# Ventura County Cultural Heritage Board Agenda

# Staff Report and Recommendations

## Agenda of April 11, 2016, Item 4

On behalf of the Property Owner, the Applicant requests a Certificate of Review [County Cultural Heritage Ordinance (CHO) Code §1364-12] for new construction of a 1,200 square foot second dwelling unit and associated covered porches, 576 square foot attached carport and 2,023 square foot barn on the subject site located at 1466 Bardsdale Avenue, in the unincorporated area of Fillmore, CA. This property is a designated Site of Merit. Case No. CH16-0001.

PLOT PLAN

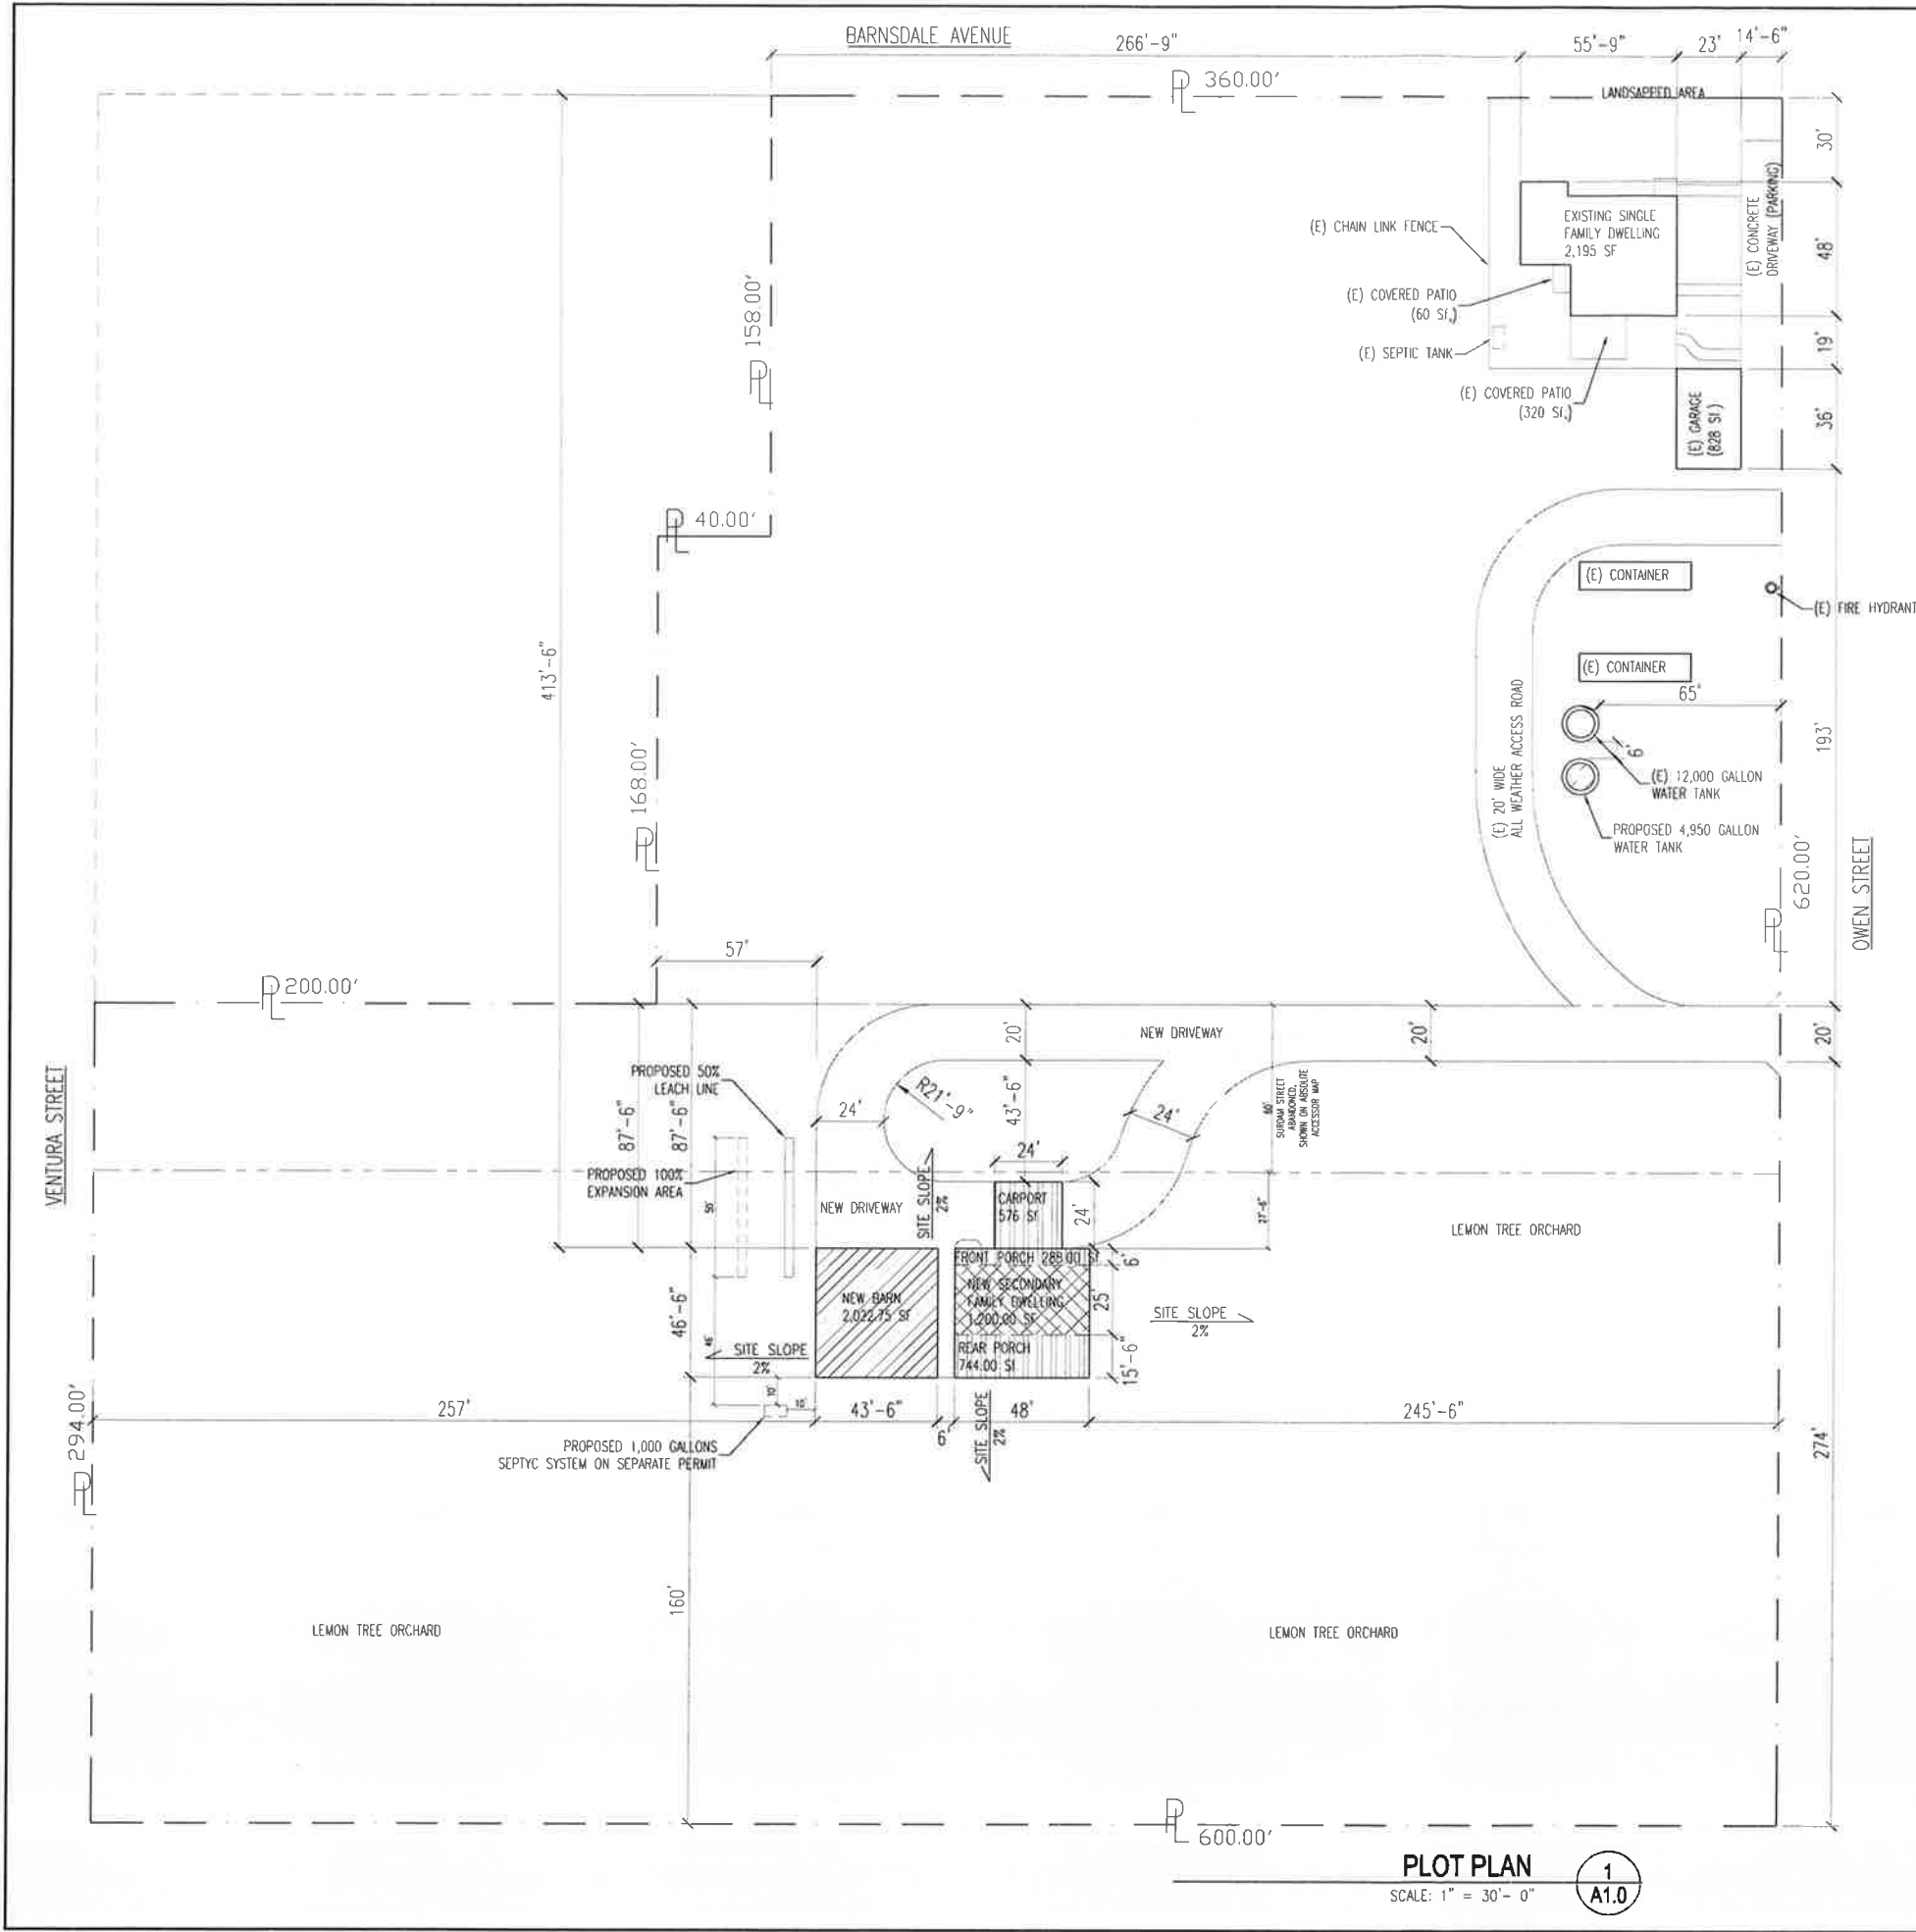
The proposed buildings will not be visible from the primary elevation (Bardsdale) and will be marginally visible from the secondary elevation (Owen) since the proposed construction site is surrounded by newly planted citrus trees. The proposed buildings will be setback from the main residence approximately 370 feet and setback from Owen Street approximately 300 feet. The building footprint of the second dwelling, including its covered porches, and attached carport (totalling 2,826 s.f.) will be slightly larger than the main residence's building footprint of 2,700 s.f. which will give this building an appearance of being slightly larger, however, the proposed construction will be located in the center of the seven acre property and surrounded by newly planted citrus trees that will hide these buildings from public view once they mature.

The proposed project will be setback from the main residence approximately 300 feet and surrounded by a citrus grove. As proposed, these buildings will not be visible from the primary elevation (Bardsdale) and will be marginally visible from the secondary elevation (Owen) once the newly planted citrus trees mature. The essential form, setting and integrity of the Site of Merit as a contributor to an eligible agricultural historic district will be preserved.

EAST AND SOUTH ELEVATIONS

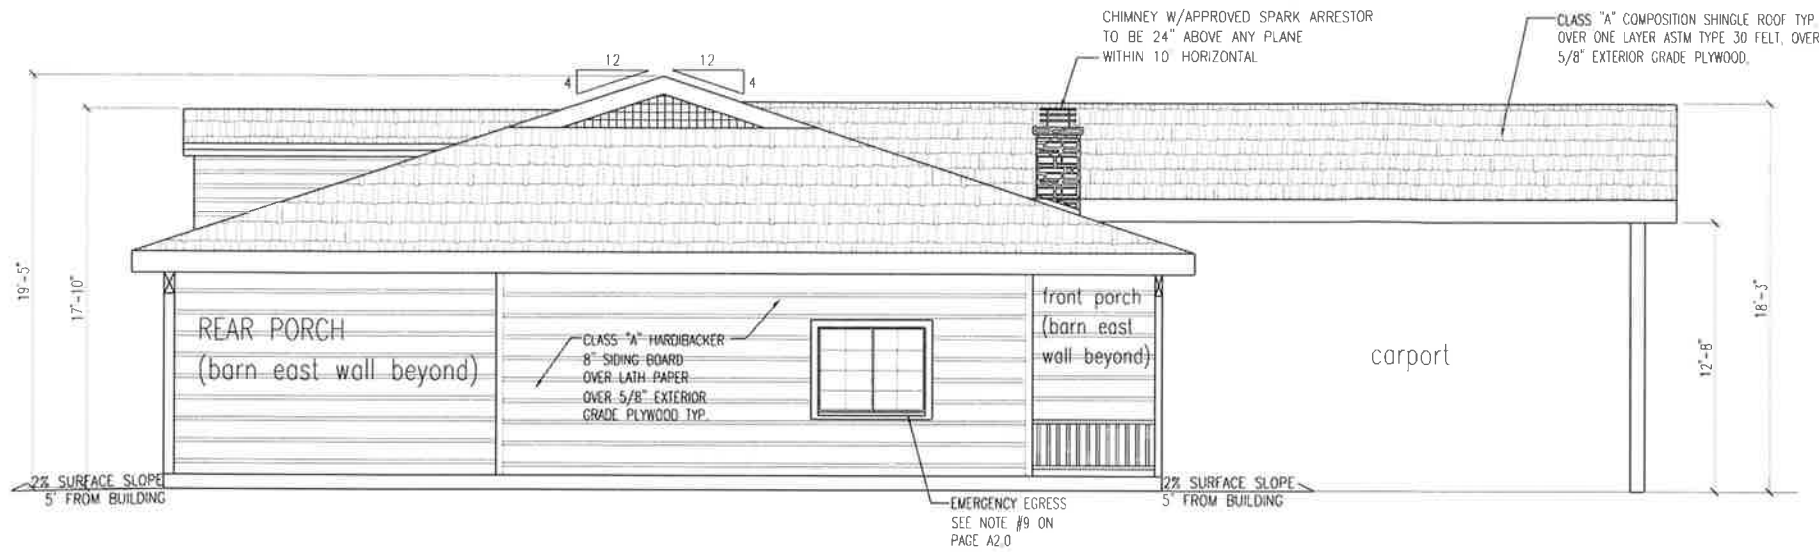
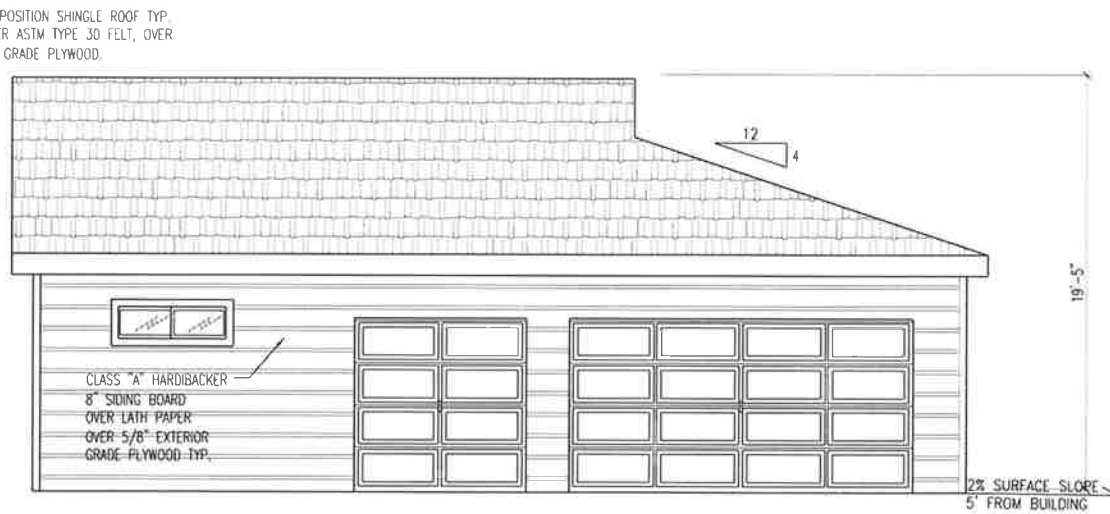
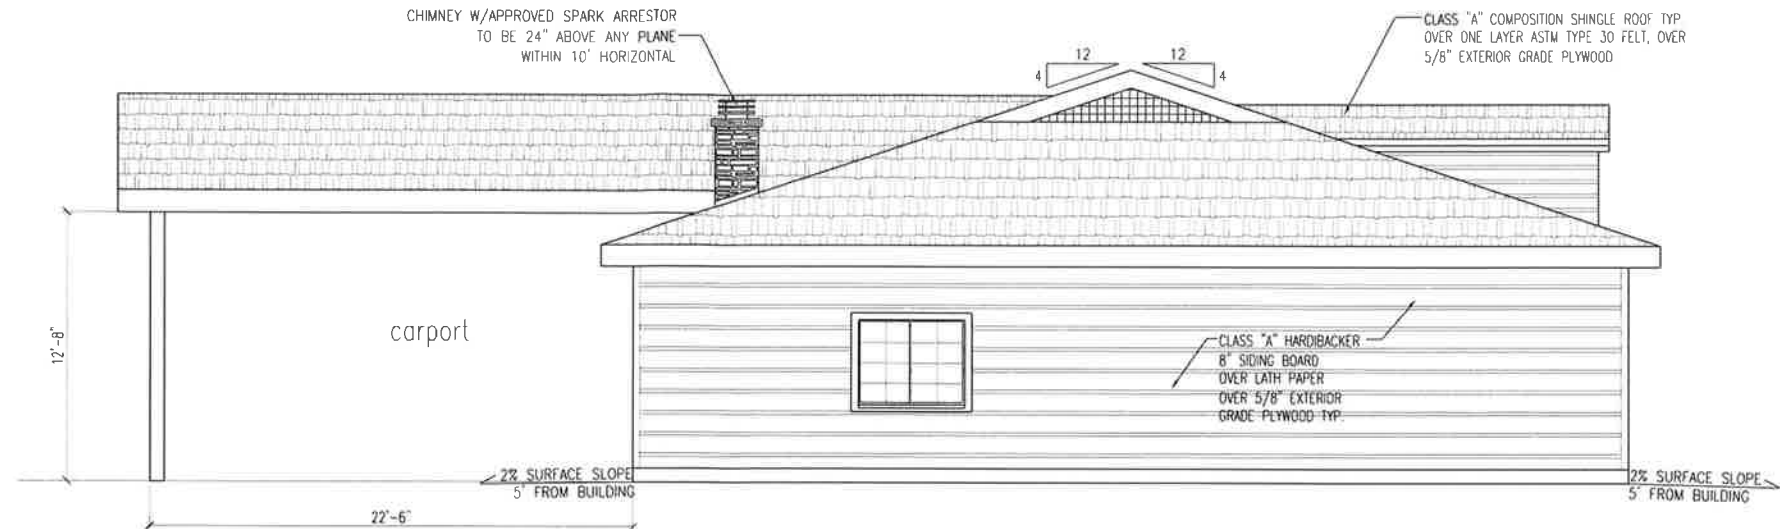
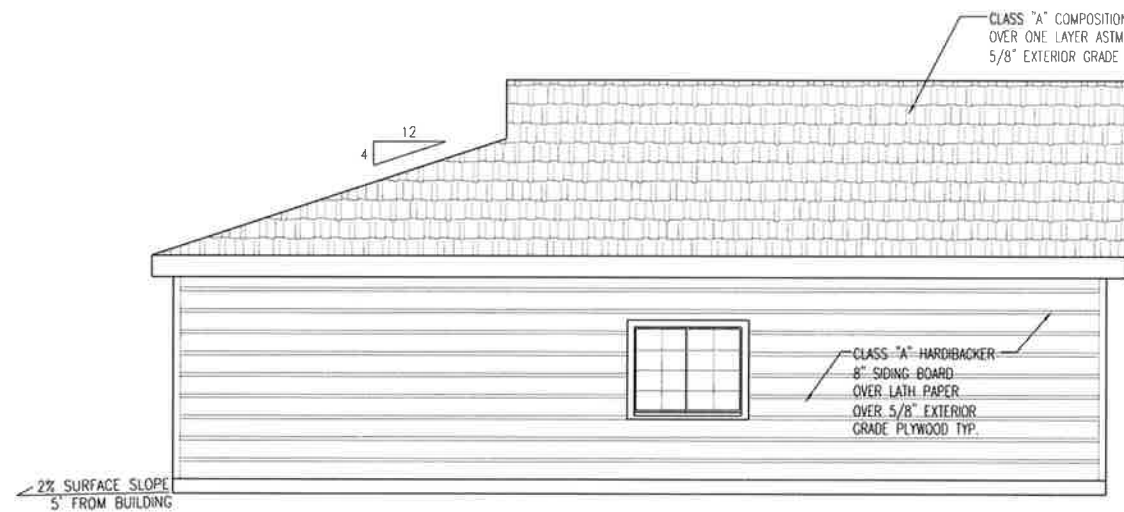
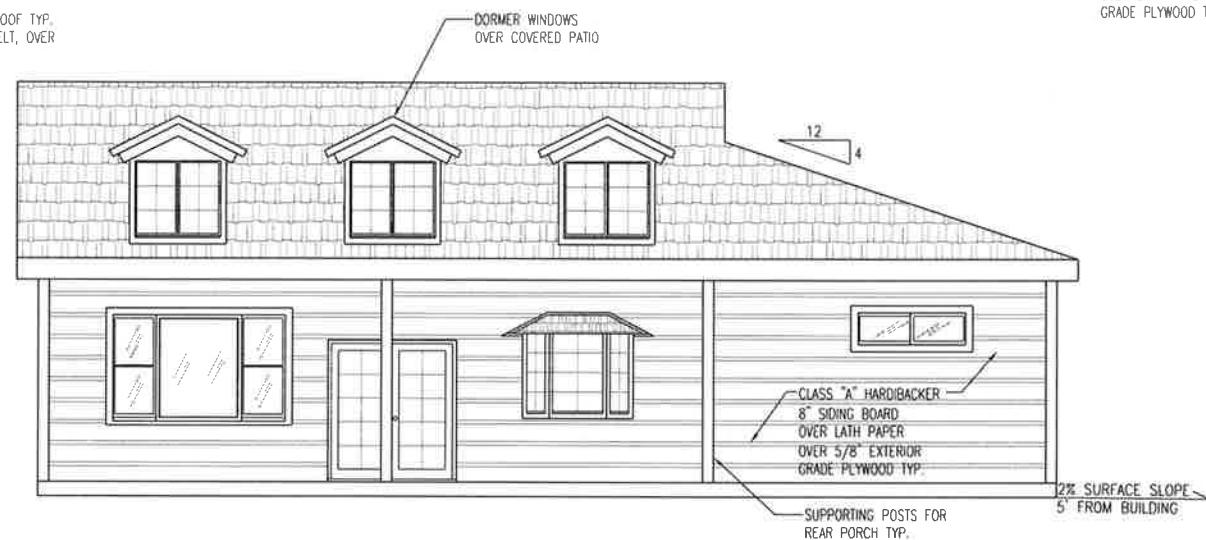
The proposed one-story 1,200 square foot (s.f.) second dwelling is designed in a square shape with a hip roof and clad in HardiePlank lap siding, with an attached 576 square foot porte-cochère carport, 285 s.f. front porch, and three pedimented dormers over the 765 s.f. covered rear porch. The proposed one-story 2,023 s.f. barn is designed in a square shape with a hip roof and clad in HardiPlank lap siding. Staff believes the HardiePlank siding proposed on both the barn and the second dwelling could easily be recognized as new construction due to its thin profile (1/4 inch in section and untampered). The new construction will be differentiated from the main residence but be compatible with its massing, size, scale, and design.

Discussion - Staff believes the materials and finishes that are proposed in the new construction will be compatible with the existing Victorian style of the main residence. The proposed second dwelling and barn appear to incorporate some elements found in 19<sup>th</sup> Century design such as pedimented dormers, porte-cochère carport, and lap siding however, the proposed project's design is more contemporary.

Discussion The existing one-story main residence and garage is located near the northeast corner of Bardsdale Avenue and Owen Street. The height of the second dwelling and barn will be approximately 19.5 feet at roof peak which is approximately the same height as the main residence. The new construction of a detached one-story 1,200 square foot second dwelling with an attached 576 s.f. carport, two covered porches totaling 1,021 s.f. and a detached 2,023 s.f. barn will be setback from the main residence and surrounded by an existing citrus grove. As proposed, these buildings will not be visible from the primary elevation (Bardsdale) and will be slightly visible from the secondary elevation (Owen) at the 20 foot wide access road to the second dwelling's circular drive. Thus, the essential form, setting, and integrity of the Site of Merit as a contributor to an eligible agricultural historic district property and its environment would be unimpaired.
